DEVELOPMENT MANAGEMENT COMMITTEE

23rd September 2021

ADDENDUM SHEET

Proposed Ground Floor Site Plan – Amenity (Reference 1094-G11)

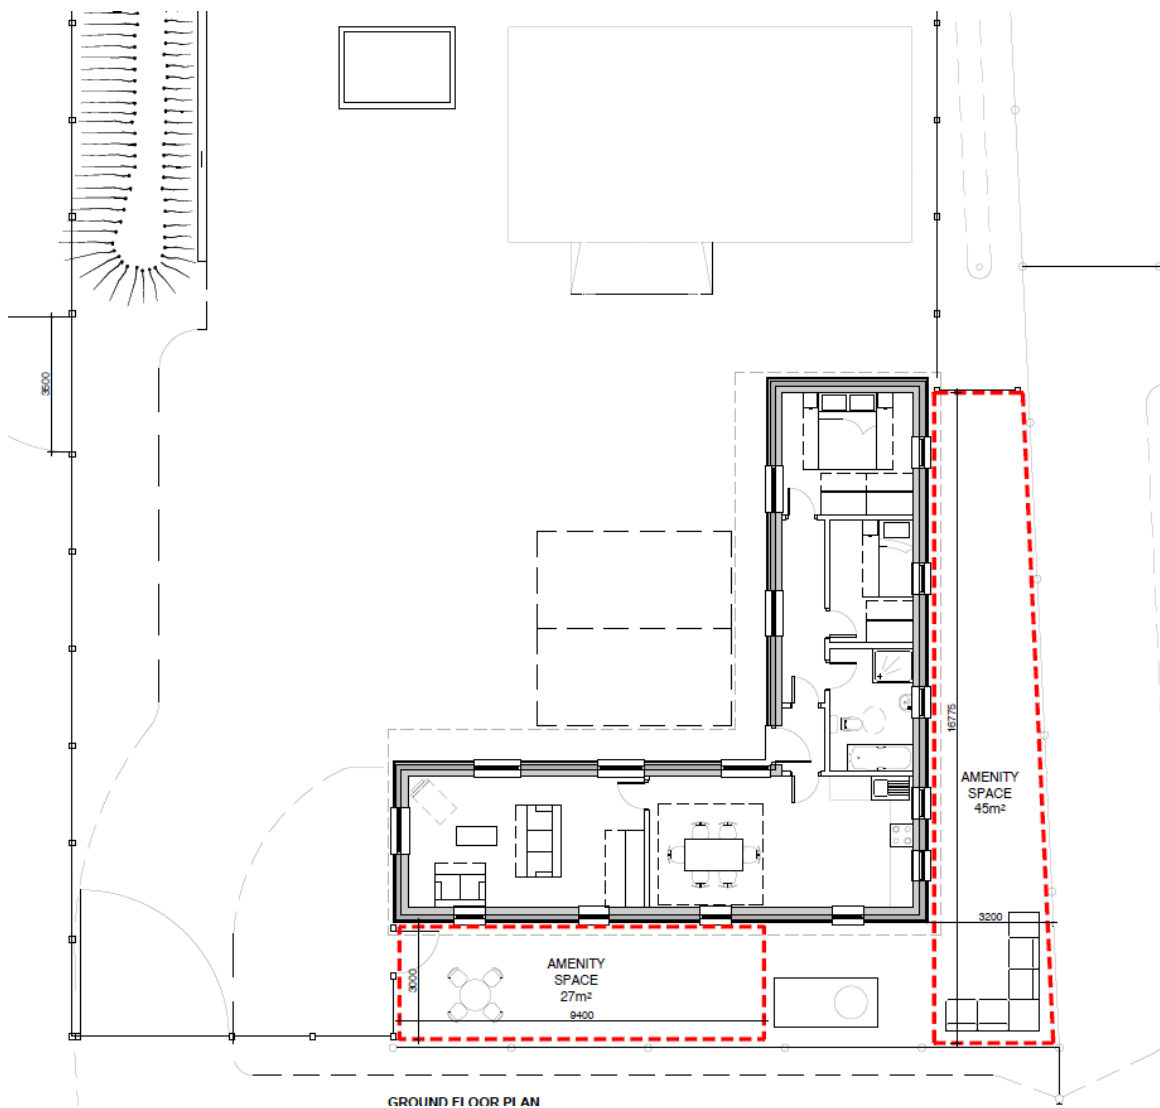
The agent has submitted two additional plans, indicating the proposed amenity space arrangements and proposed provision for electric vehicles:

- 1) Proposed Ground Floor Site Plan – Amenity (Reference 1094-G11)
- 2) Proposed Site Plan – Electric Vehicles (Reference 1094-G12).

Proposed Site Plan – Electric Vehicles (Reference 1094-G12)

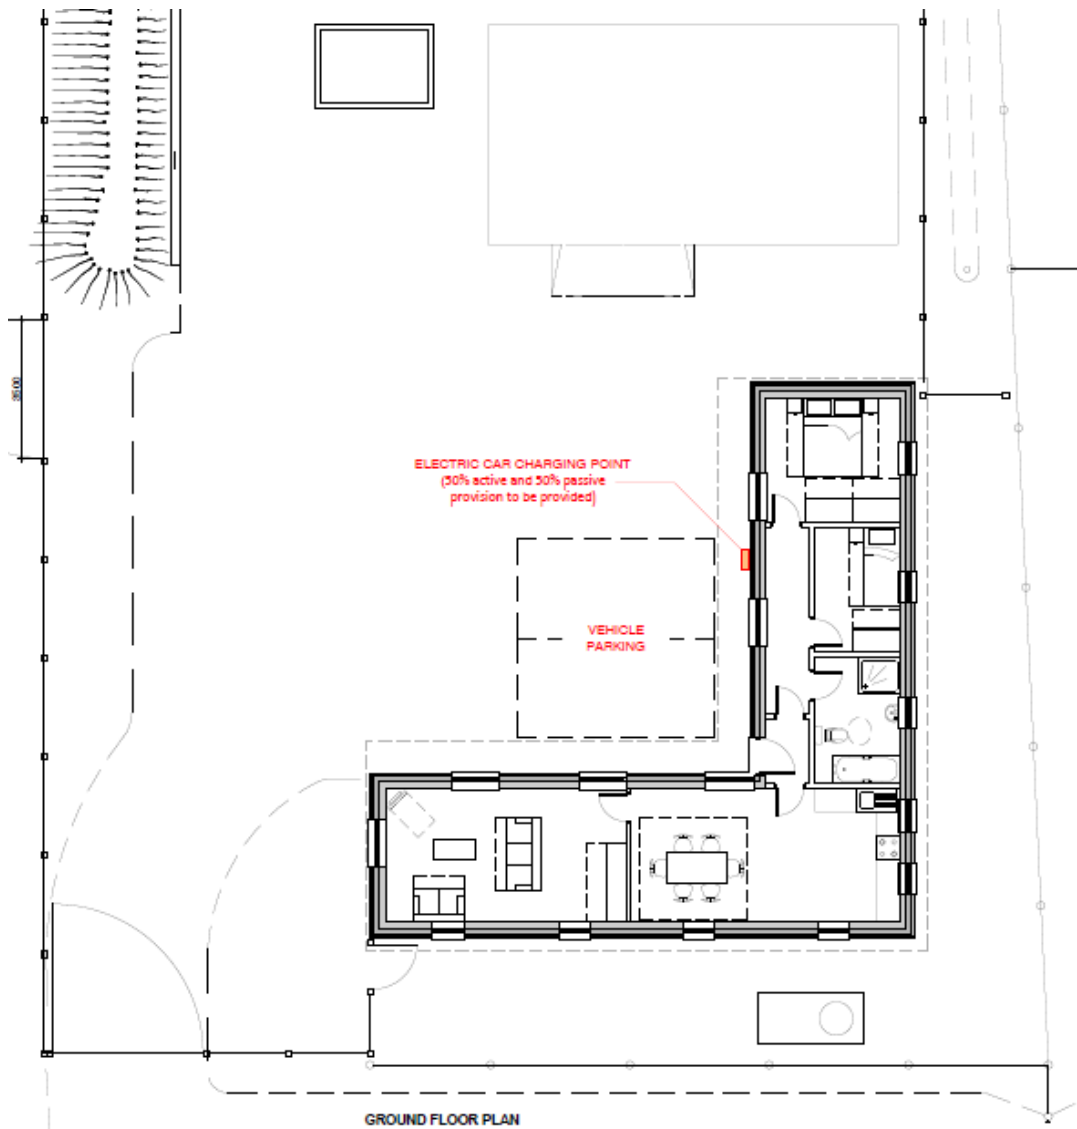
Given that the proposed arrangements for electric vehicle provision have been provided, it is recommended that Condition 6 (Electric Vehicles) be amended to read as follows:

The dwelling hereby approved shall not be occupied until the Electric Vehicle Charging Points and associated infrastructure has been provided in accordance with drawing 1094-G12. The Electric Vehicle Charging points and associated infrastructure shall thereafter be retained in accordance with the approved details.

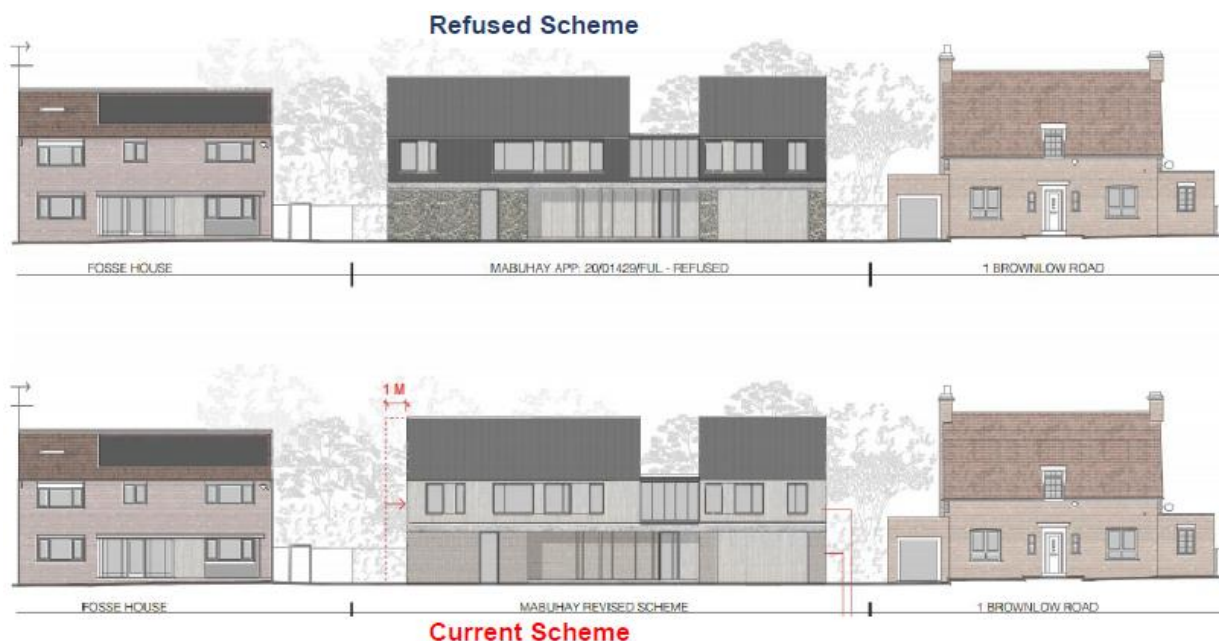
- **The frontage width of the building has been reduced by 1m;**
- **The zinc cladding proposed at first floor level has been omitted and replaced with timber cladding; and**
- **The flint proposed at ground floor level has been omitted and replaced with facing brick**

The proposed changes to external facing materials of the building will ensure that the building will be more muted and visually recessive than as previously proposed. The snipped comparative frontage elevations and the proposed site plan extracts below show the effects of these changes relative to the refused scheme. However, and importantly, the current plans also demonstrate that the changes do not dilute the high quality contemporary design and form of the proposed building nor diminish the more positive overall contribution that the building will make to the character and appearance of the surrounding area.
